NEW JERSEY DEPT OF ENVIRONMENTAL PROTECTION TRENTON
NATIONAL DAM SAFETY PROGRAM. ALLAMUCHY POND DAM (NJ00501), DELA--ETC(U)
MAR 80 W A GUINAN DACW61-79-C-0011

**ALLAMUCHY
POND DAM
NJ 00501**

**PHASE 1 INSPECTION REPORT
NATIONAL DAM SAFETY PROGRAM**

PHASE I INSPECTION REPORT
NATIONAL DAM SAFETY PROGRAM

5 NOVEMBER 1979
FROM WEST EDGE OF SPILLWAY LOOKING AT SPILLWAY CREST. NOTE
LOG ACROSS THE SPILLWAY.

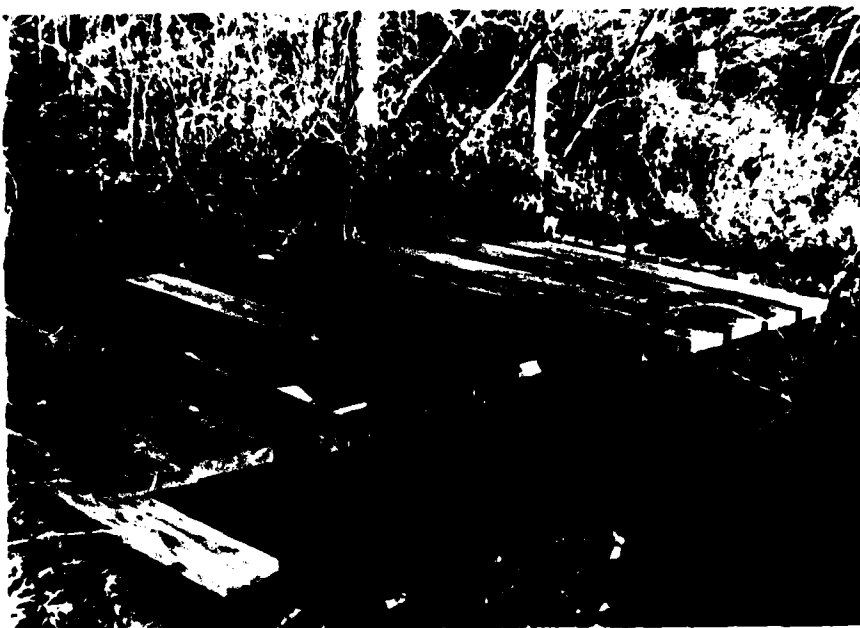
b. Appurtenant Structures. A log is lodged at the entrance to the spillway. A large piece of concrete on the west bank of the spillway discharge channel appears to be a remnant of a training wall that has fallen over. However, since a considerable quantity of debris has been dumped in the same general area, it is not certain that this concrete is, in fact, the remnant of a training wall.

(2) Remove the log from the entrance to the spillway.

5 NOVEMBER 1979
GATE MECHANISM FOR FORMER PENSTOCK. PENSTOCK SECTIONS LIE IN
RUSTED UNCONNECTED SECTIONS DOWNSTREAM.

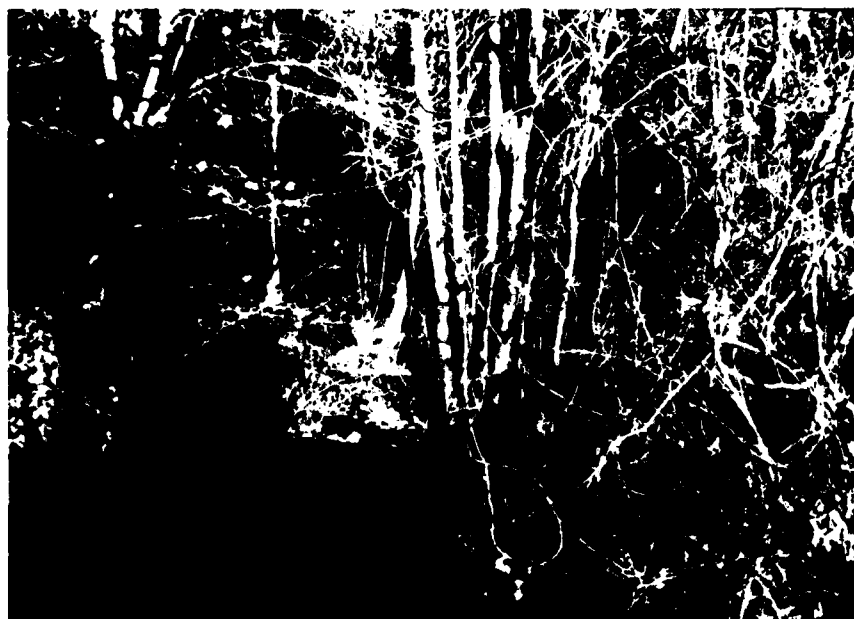
The operating facilities of the former water power intake and penstock have not been maintained and are presently in severe disrepair. Maintenance for the operating facilities has not taken place for an undetermined number of years.

(3) Restore the low-level gate operating mechanism to an operable condition and provide a downstream outlet to the discharge pipe.
